Migrating from Am29DL32xD Family to Am29DL32xG Family

Application Note

July 2003

Figure 1. Process Revision D Mapping SecSi Sector to Bottom (Left) and Top (Right) Boot Devices

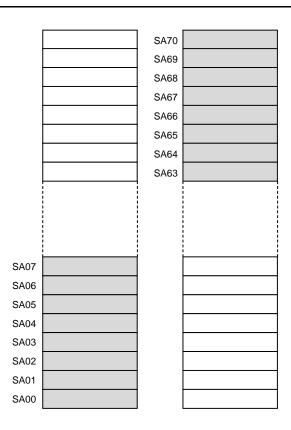
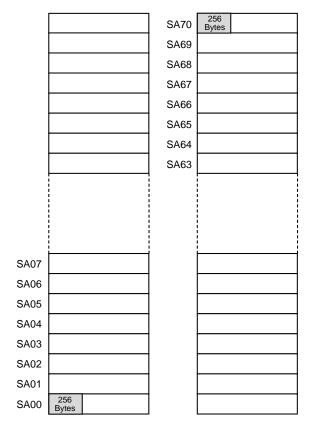
The implementation of the SecSi Sector in the Am29DL322D, Am29DL323D and Am29DL324D devices using Process Revision D technology is comprised of 64 Kbytes capable of multiple program-and-erase cycles. The implementation using Process Revision G technology introduces three fundamental changes to the previous implementation:

■ The size of the SecSi Sector is now 256 Bytes.

■ The mapping of the SecSi Sector has been changed to match the new size and is now located at the lowest or highest addresses in the device for bottom or top boot devices respectively.

■ The SecSi Sector can not be erased after being programmed, that is, it is One Time Programmable (OTP).

Thus, for a Bottom Boot device the SecSi Sector overlays (replaces) sectors SA0 to SA7 at byte addresses 000000h–00FFFFh. For a Top Boot device the SecSi Sector overlays sectors SA63 to SA70 at byte addresses 3F0000h–3FFFFFh. In addition, devices that have a factory programmed ESN, a Bottom Boot device will have the 16-byte ESN at byte addresses 00E000h–00E00Fh. A Top Boot device will have the ESN at byte addresses 3FE000h–3FE00Fh (see Figure 1).

The SecSi Sector overlays only the first 256 bytes of Sector 0 in a bottom boot device at byte addresses 000000h–0000FFh or the first 256 bytes of sector 70 in a top boot device at byte addresses 3FE000h–3FE0FFh. Accessing data outside the 256 byte range will return the data normally found within the boot sectors at the location accessed.

Restrict the use of the SecSi Sector to store only those values that will not change during the life of the system. There is no ability to erase information in the SecSi Sector after programming. There is only the ability to protect the information from further programming.

The reduction in size to 256 bytes from 64 Kbytes makes it difficult to store a significant amount of code in the SecSi Sector. Therefore, code that formerly used the SecSi Sector may need to be moved to another sector.

Code which references SecSi Sector information will have to take into account the new address mapping of the SecSi Sector.
